DART AEROSPACE LTD	Work Order: 78423
Description: Crosstube Assembly (205/212/412 High Fwd)	Part Number: D212-664-141
Inspection Dwg: D212-664-141 Rev: D	Page 1 of 1

DRAWING NO. D212-664-141	TITLE XTUBE ASSY (205/212/412 HI FWD)	REV. D	DART AEROSPACE LTD ENGINEERING ORDER		D.E.O. NO. D212-664-141-D-1	SHEET NO. SHEET 1 OF 2	SCALE NTS
DRAWN	CHECKED	MFG. APPR.	APPROVED	DE APPR.	DATE	DATE	DATE
11.04.07	11.07.11	11.04.12	11/04/12	11.04.12	11.04.12	11.04.12	11.04.12

DRAWING NO. D212-664-141	TITLE CROSSTUBE ASS'Y (205 HI FWD)	REV. D	DART AEROSPACE LTD ENGINEERING ORDER		D.E.O. NO. D212-664-141-D-2	SHEET NO. SHEET 1 OF 1	SCALE NTS
DRAWN <i>UP</i>	CHECKED <i>ADS</i>	MFG. APPR. <i>AS</i>	APPROVED <i>MD</i>	DE APPR. <i>HH</i>			
DATE 11.07.15	DATE 11.07.20	DATE 11.07.21	DATE 11/07/21	DATE 11.07.21

**D212-664-141/-141B
ASSEMBLY DETAIL**

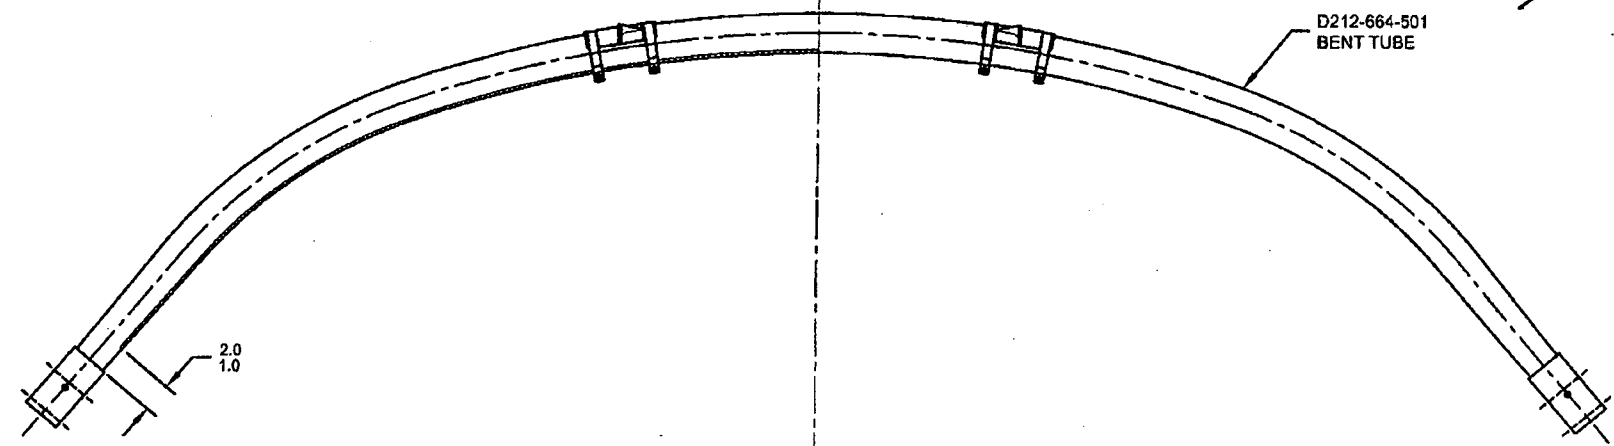
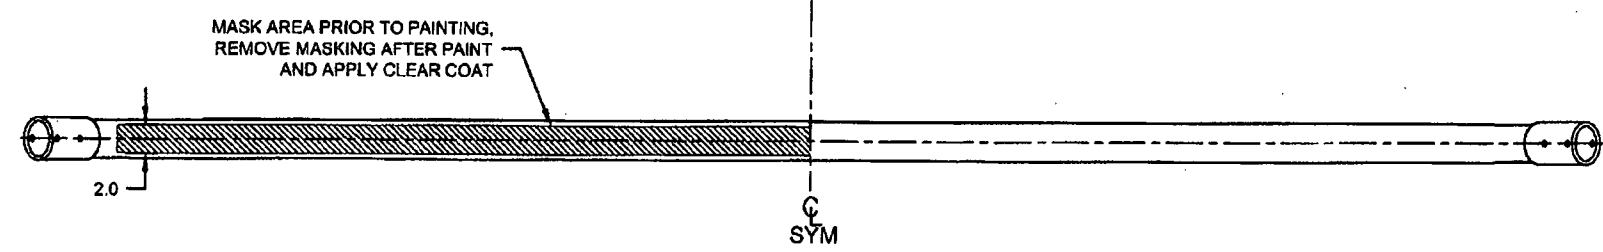
PURPOSE:

ADD AN INSPECTION WINDOW TO UNDERSIDE OF CROSSTUBE.

CHANGE:

IS:

WAS:
